VEHICLE RECALL

G - 05505

SUBJECT: SAFETY RECALL (U.S., EXPORT)

Engine cover lid on certain FE School Bus and FE Commercial Bus models built between 09-04-2003 and 02-05-2005

Figure 1

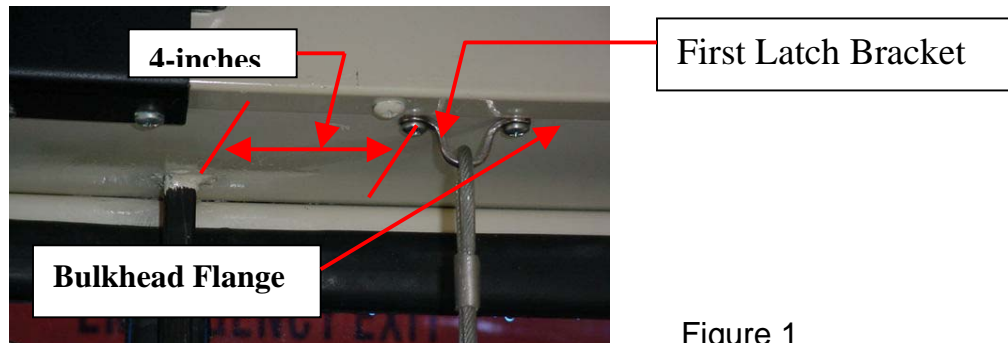
1. Mark the location of the first hole for the first latch bracket 4-inches to the right of the windshield center bar. Using the bracket as a template, align the bracket with the flange of the bulkhead to mark the location of the second hole. **Slip one end of the cable onto the bracket before attaching the bracket to the bus body.** Attach the bracket using the screws included in the kit. Figure 1 shows the result.

Figure 2

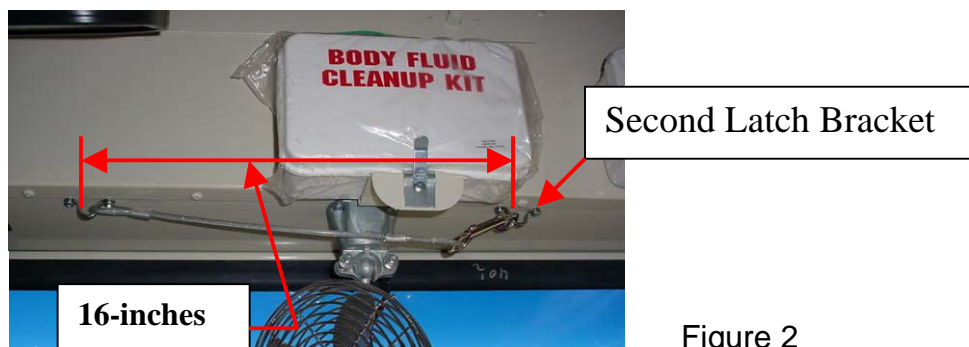
2. Before marking the holes and attaching the second bracket, make sure that the cable will reach and the snap bolt will hook onto the second bracket where you are planning to attach it.
3. Mark the location of the left hole of the second bracket 16-inches to the right of the left hole of the first bracket. Again, using the bracket as a template, align the bracket with the flange of the bulkhead to mark the location of the second hole. See Figure 2.

Figure 4

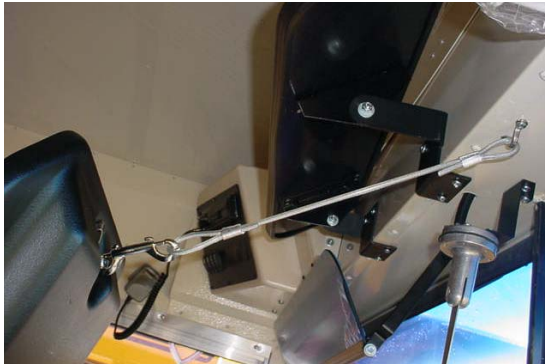
5. To retain the engine access cover in the open position, remove the cable latch from the right latch bracket and snap it on to the eye of the engine access cover latch bracket. See Figure 4.
